ADDENDUM NO. 4

February 10, 2023

SOLON ROBINSON ELEMENTARY SCHOOL ADDITIONS, RENOVATIONS, AND RELATED WORK Crown Point, IN 46307

MD101

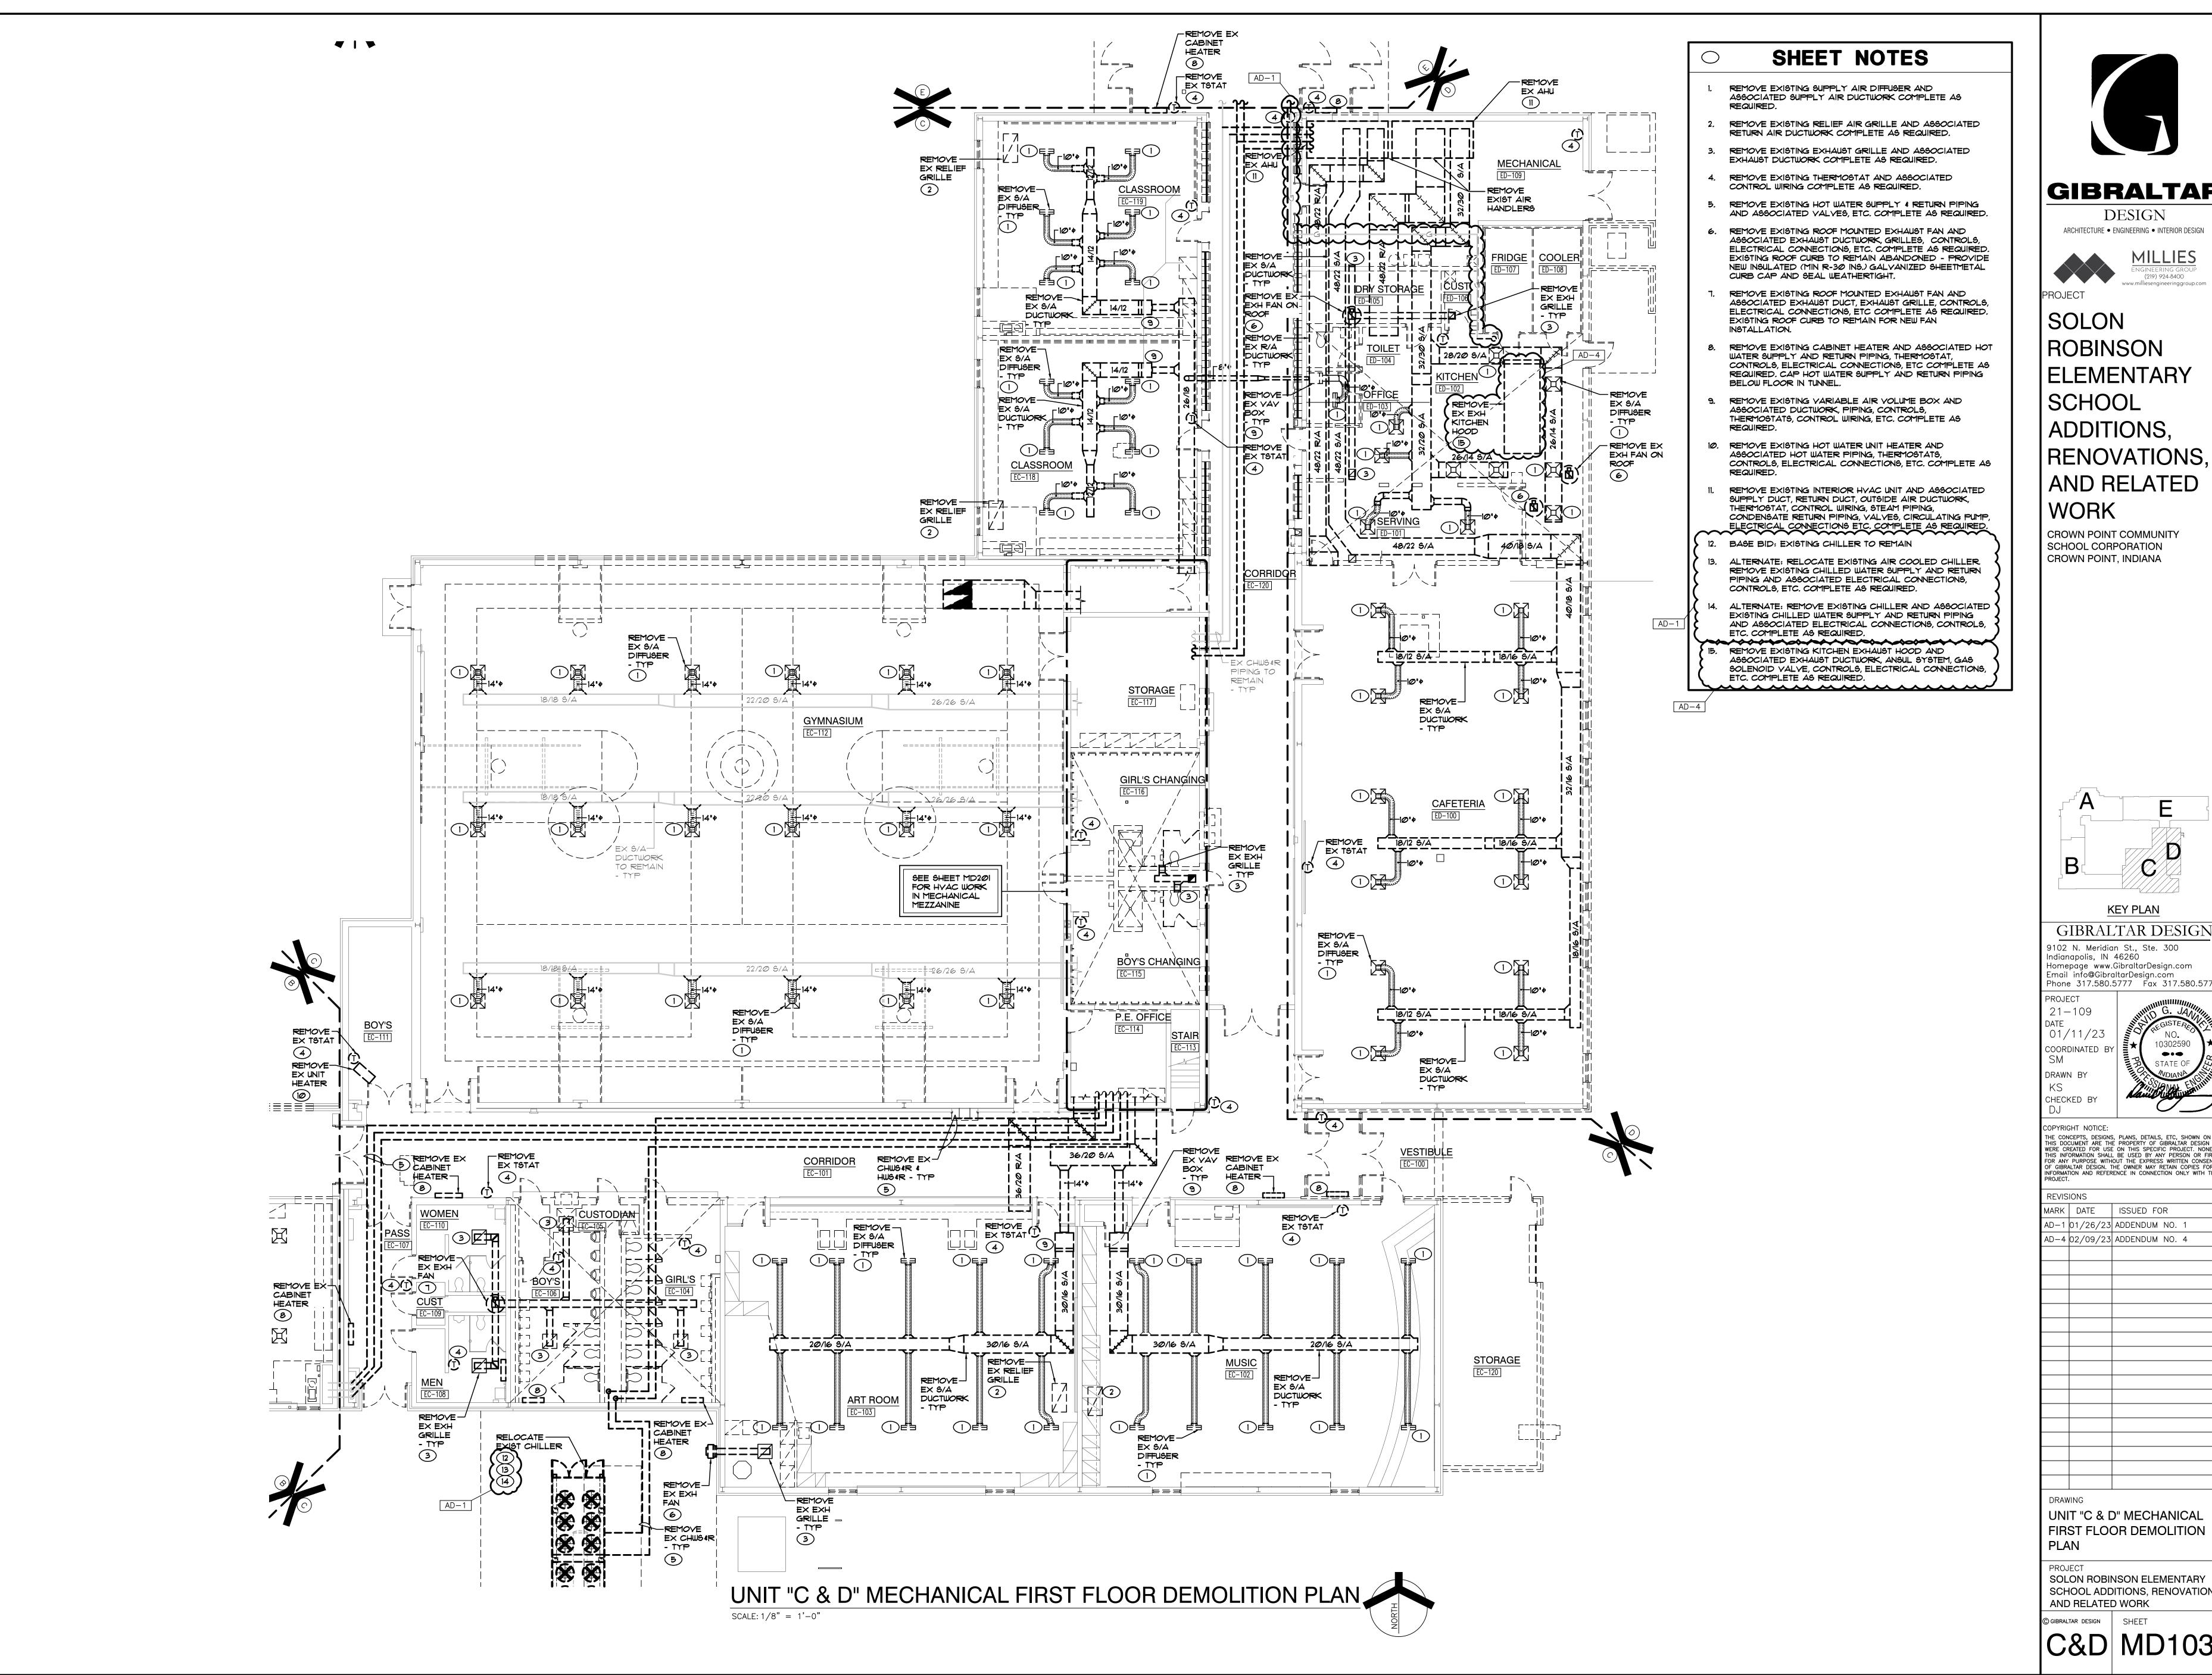
30. Sheet MD101

- A. Add demo unit ventilator.
- B. Add (2) demo rooftop units.
- C. Add sheet notes.

ED101

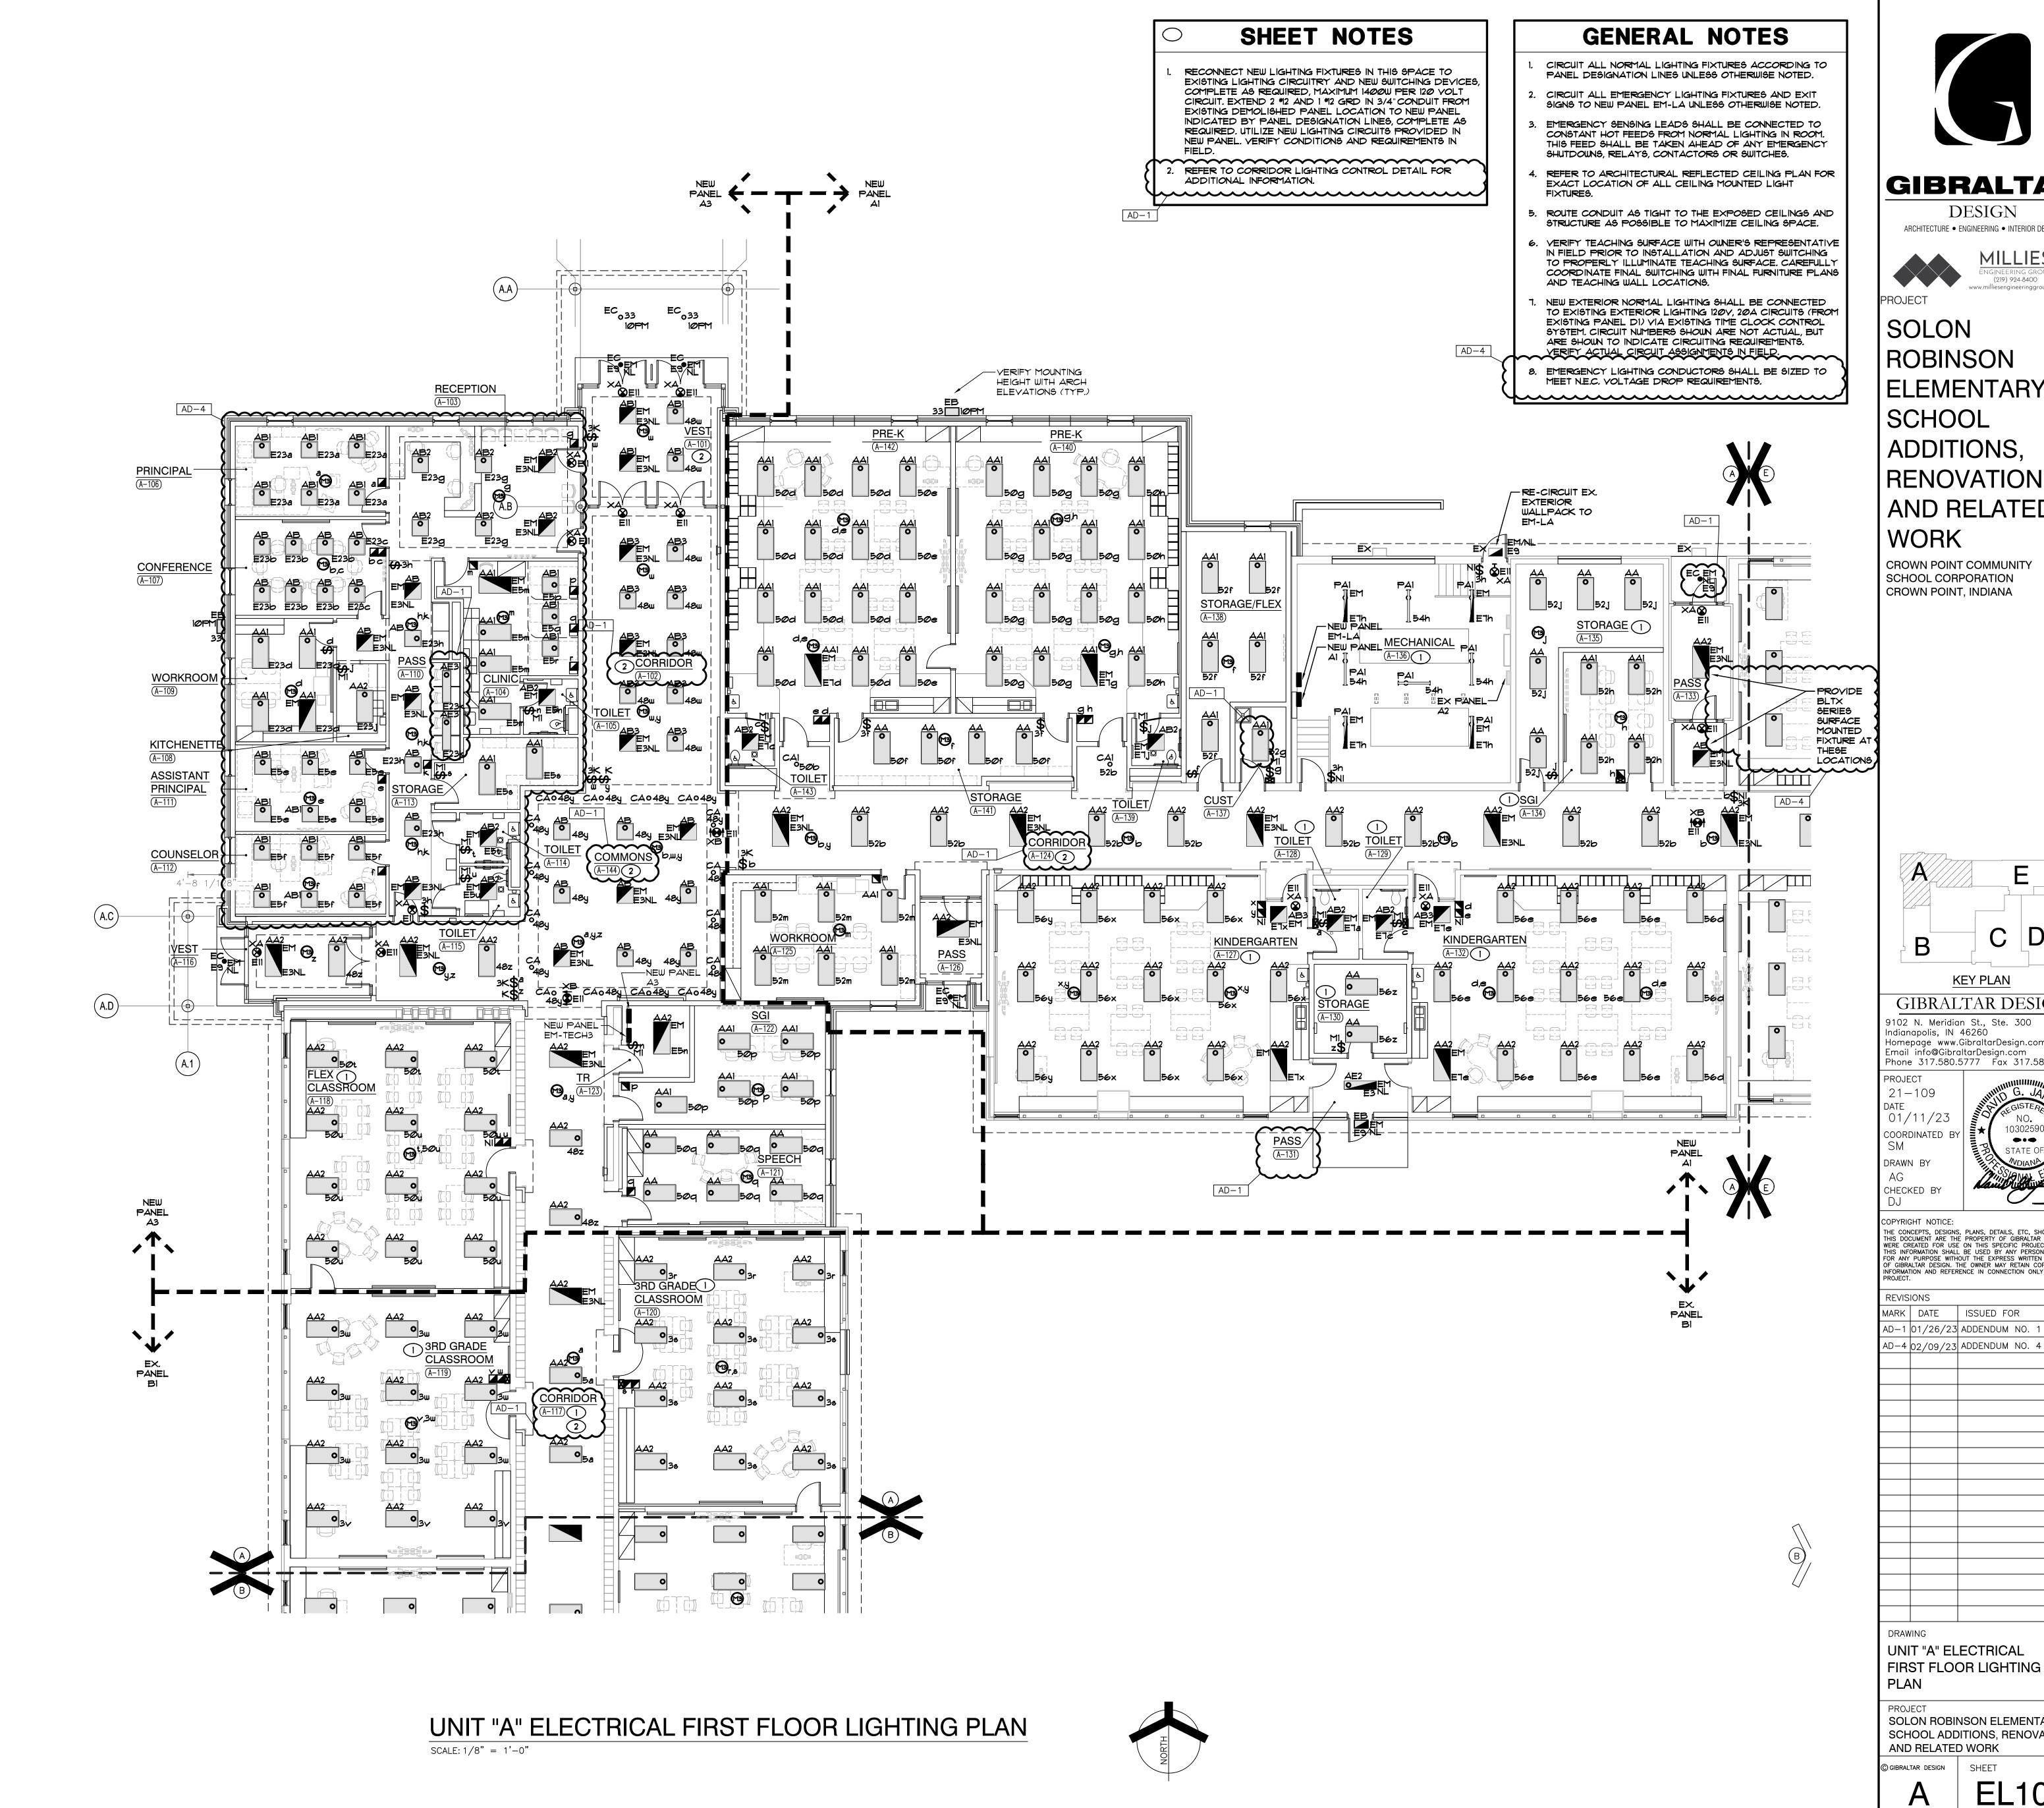
36. Sheet ED101

A. Add note.

SHEET EL105

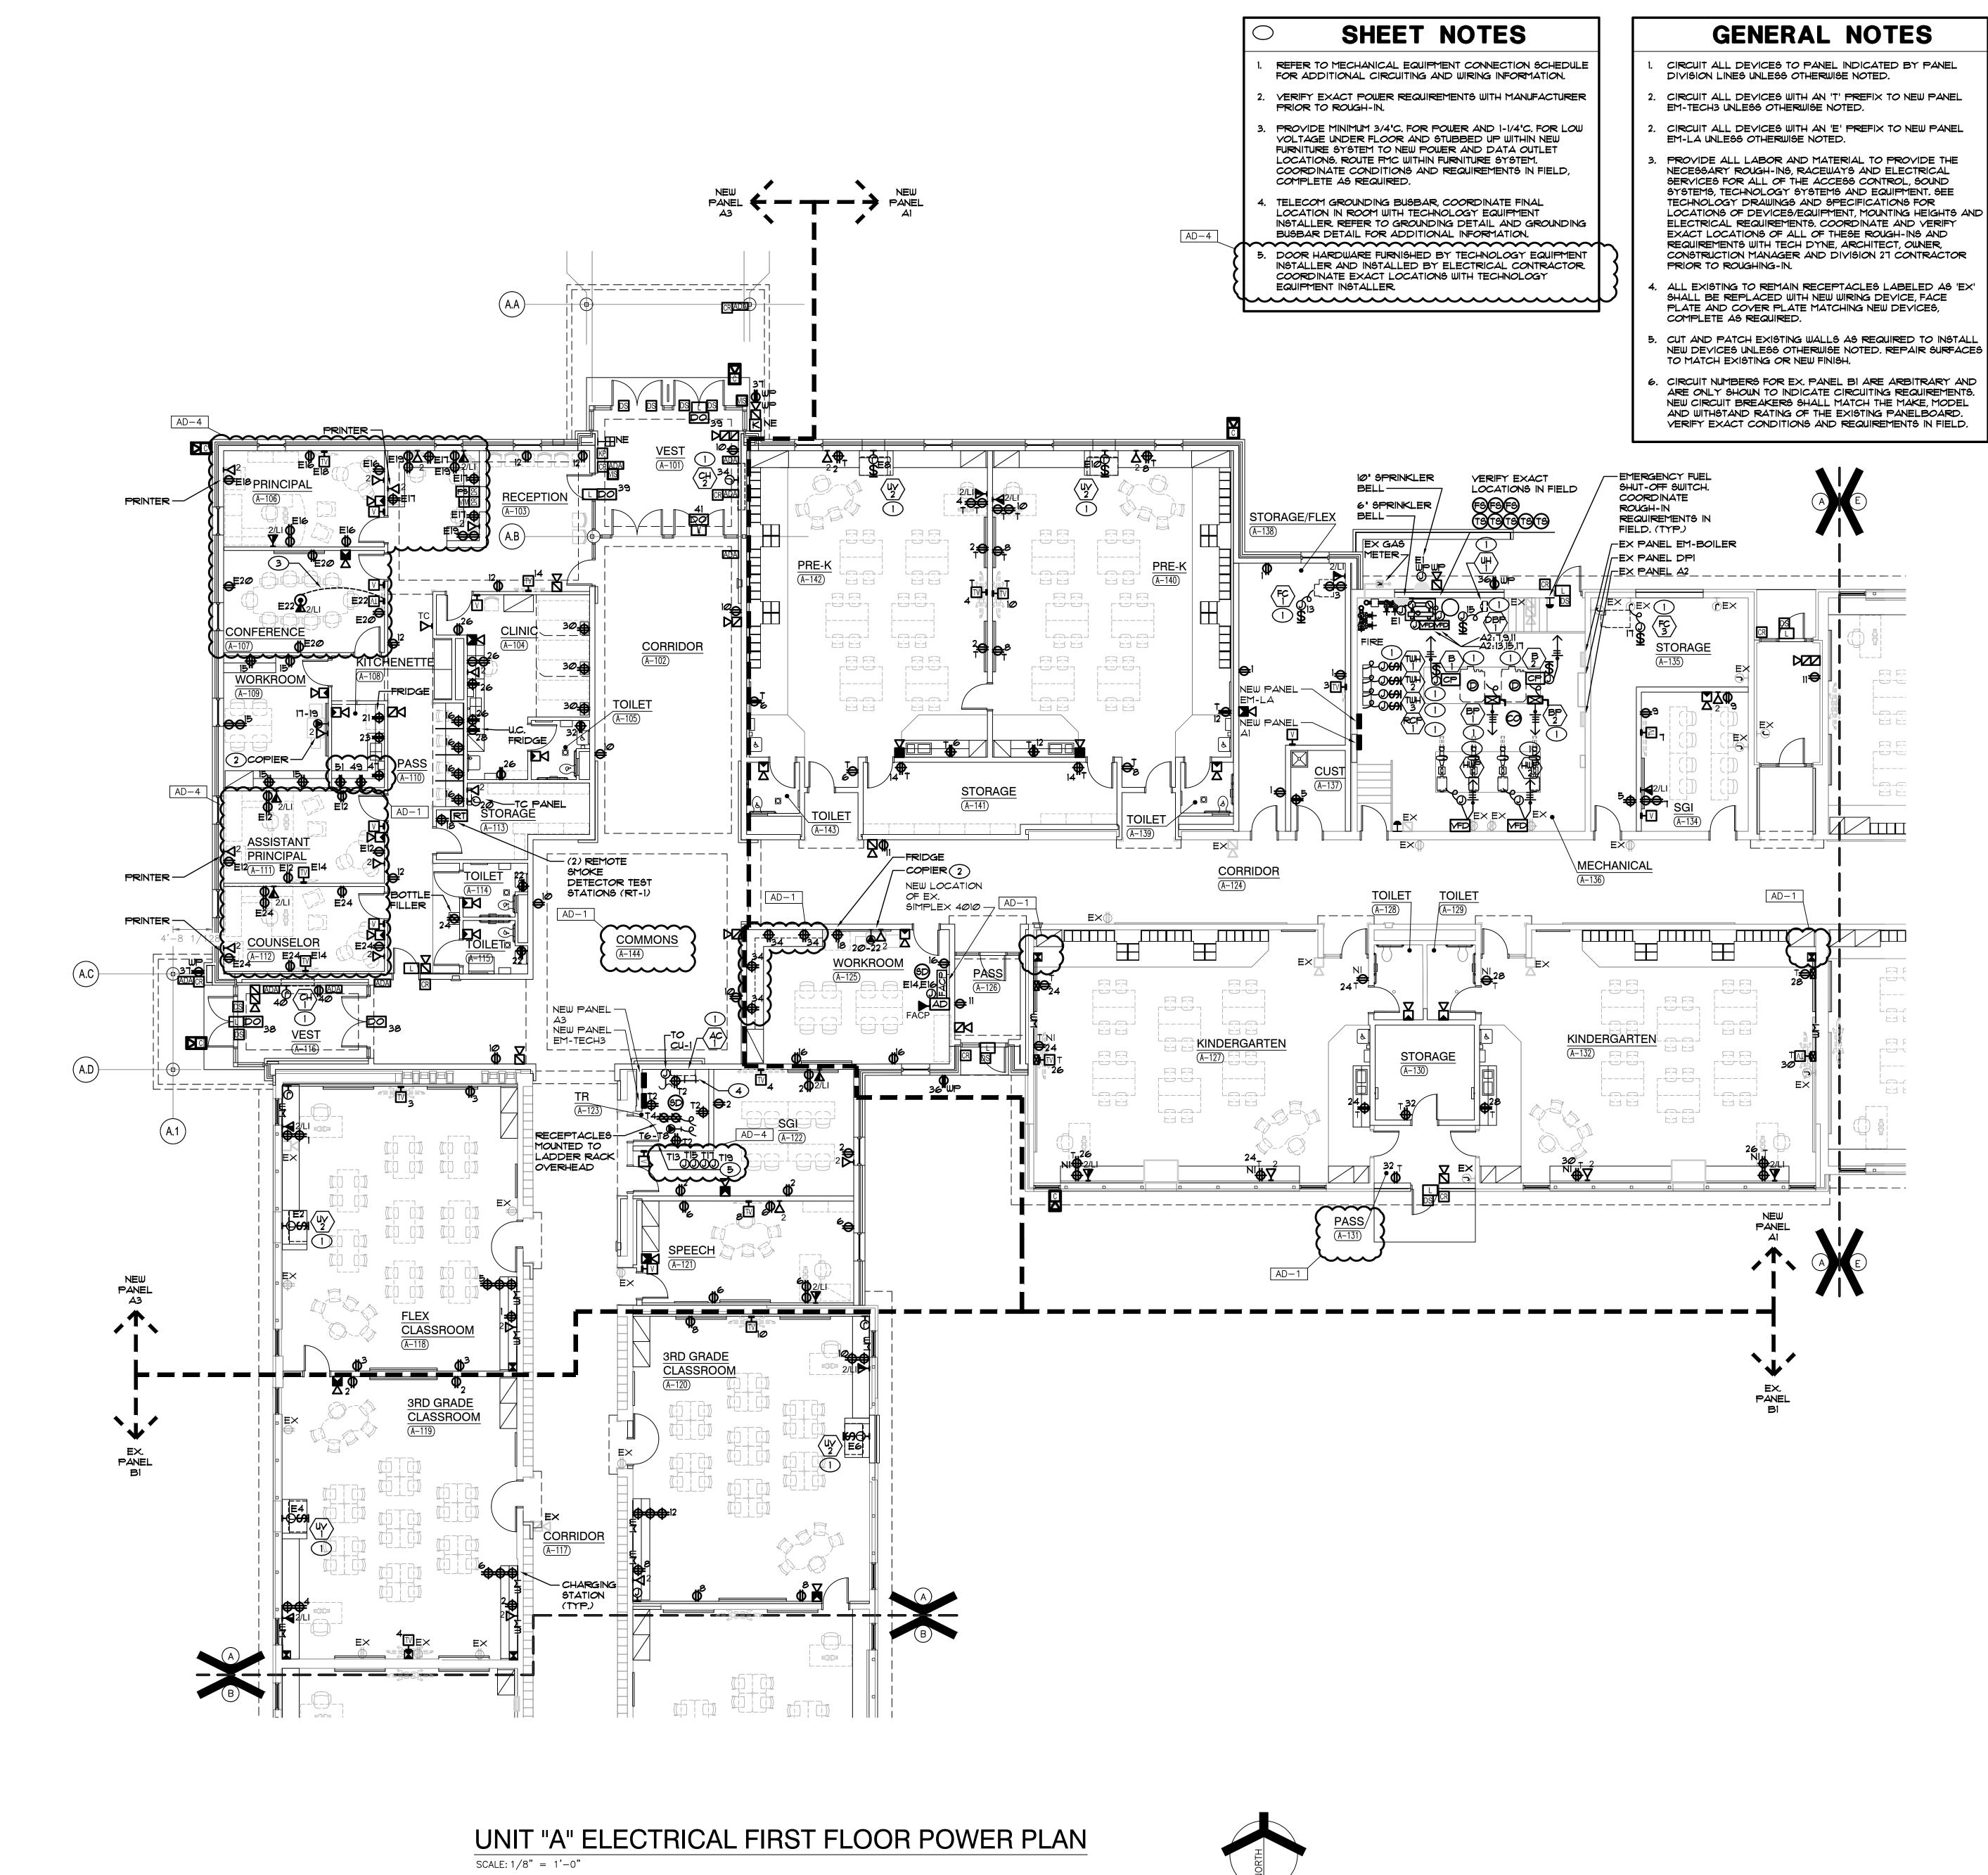
41. Sheet EL105

A. Add general note.
